## ADDENDUM NO. 4

MUSCOY ELEMENTARY SCHOOL – ADMINISTRATION OFFICE AND LIBRARY MODIFICATIONS

DSA No. 04-115436      File No. 36-55

PROJECT# 1-78-06 Project <b>MUSCOY E.S. OFFICE LIBRARY MODIFICATIONS</b>		Title <b>RESTROOM LAYOUT</b>	
 Architects-Planners ■ 3775 Tenth Street • Riverside, CA 92501-3669 • T 951 684 4664 • F 951 684 6276 ■ 5751 Palmer Way, Suite C • Carlsbad, CA 92010-7249 • T 760 438 5899 • F 760 931 8194	DSA A# <b>04-115436</b>	Date <b>03-01-17</b>	Sheet No. <b>ASK-4.1</b>
	DSA F#	Scale <b>1/4" = 1'-0"</b>

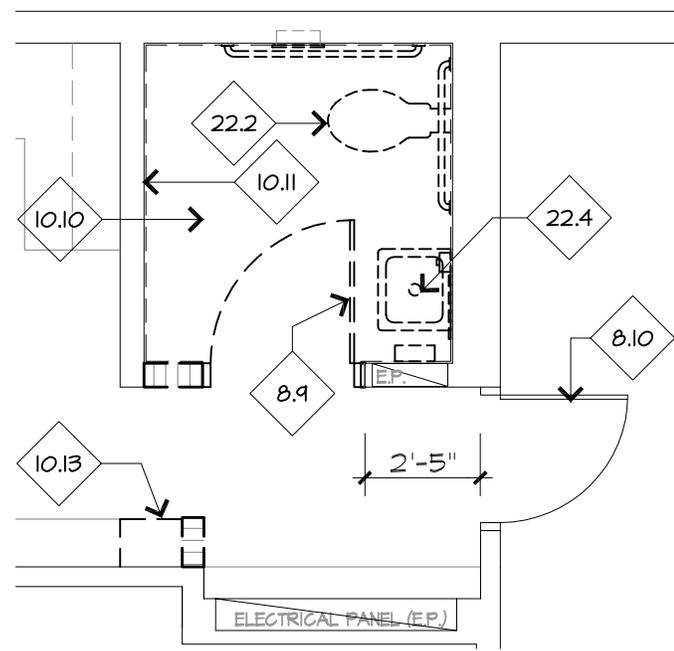
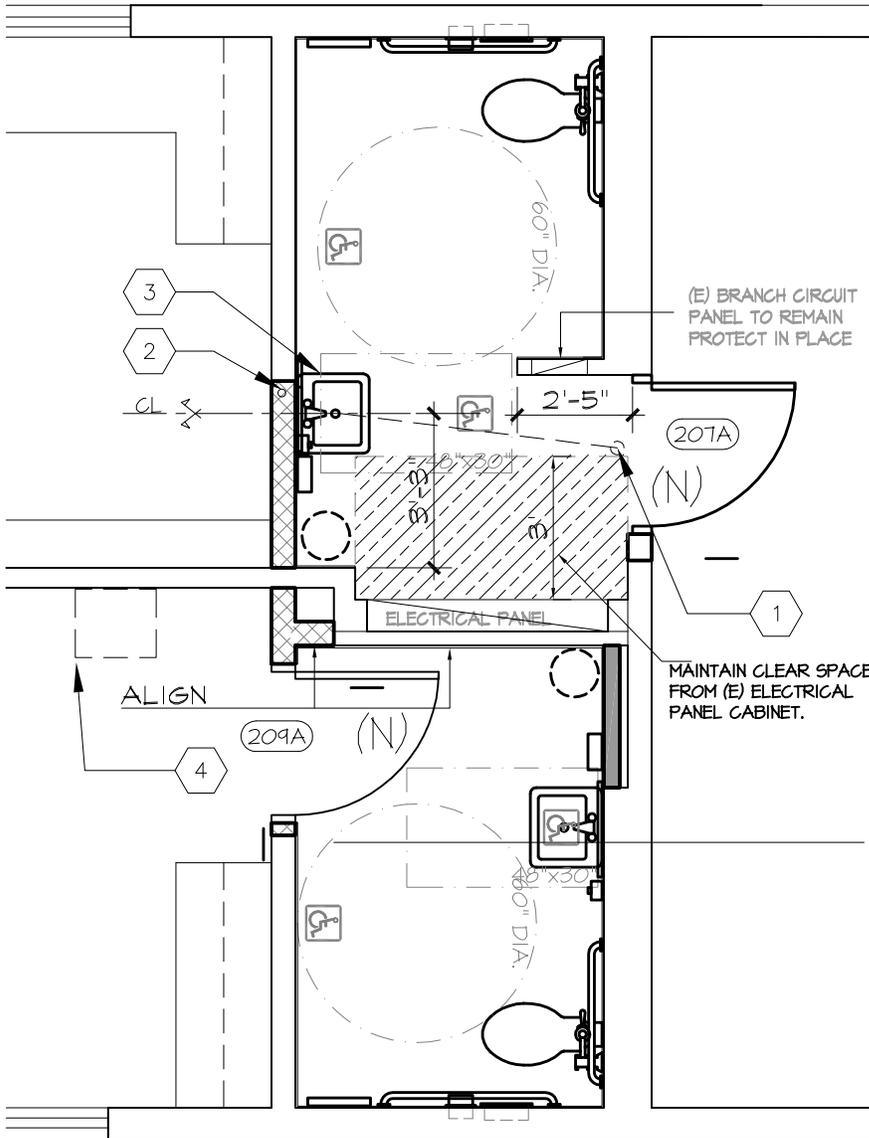
- Item No. 4.2      Reference Sheet A-1.2:  
    4.2.1      Revise Demo and New Floor Plan layout at Restroom 207 per attached Sketch ASK-4.1.
- Item No. 4.3      Reference Sheet P4-1:

1. SEWER POINT OF CONNECTION TO (E) 4" BELOW SLAB, MAKE CONNECTION AND PATCH BACK.
2. EXTEND PLUMBING VENT LINE AND CONNECT TO (E) ABOVE CEILING.
3. EXTEND COLD AND HOT WATER LINE FROM (E) P.O.C TO NEW SINK. CONTRACTOR TO FIELD VERIFY P.O.C AND MAKE FINAL CONNECTION TO FIXTURE PIPE ABOVE CEILING.
4. NEW DOWNSIZED IDF RACK. MAINTAIN 80" HEAD CLEARANCE.

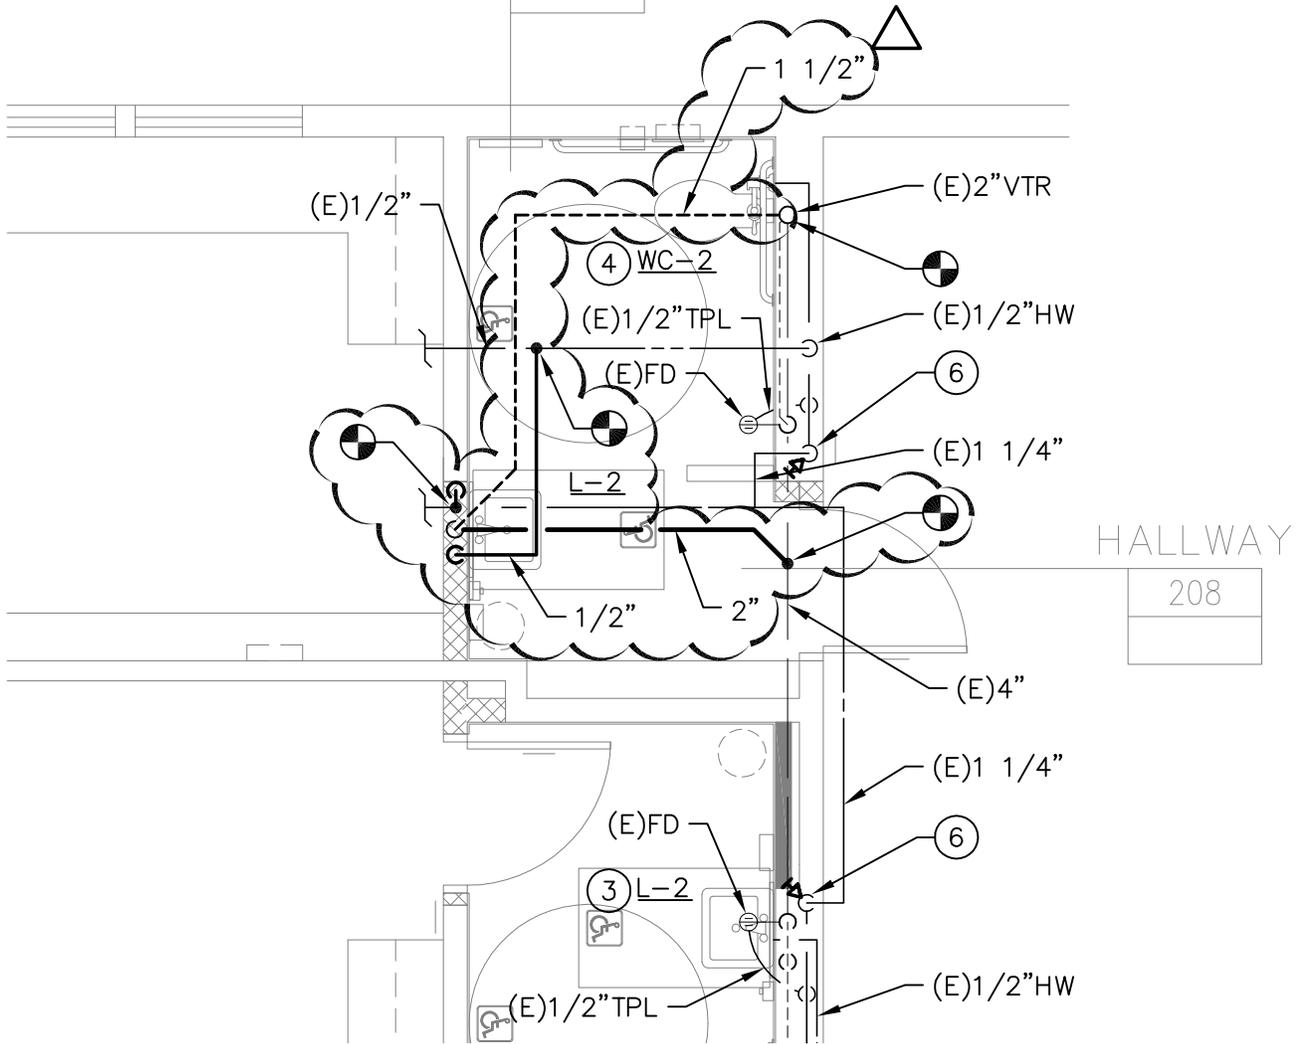
4.3.1      Contractor shall install equipment Lavatory 'L-2' on west wall of Room #207 in lieu of the east wall indicated. Provide all related connections as required. See attached sketch for additional information. Contractor shall take extreme caution when installing below grade drain line as existing utilities for the adjacent electrical panel are installed below grade in the vicinity. Lavatory exact location shall be as indicated on Architectural drawings and 36" clear space shall be maintained from Lavatory south edge to existing electrical panel located on the south wall.
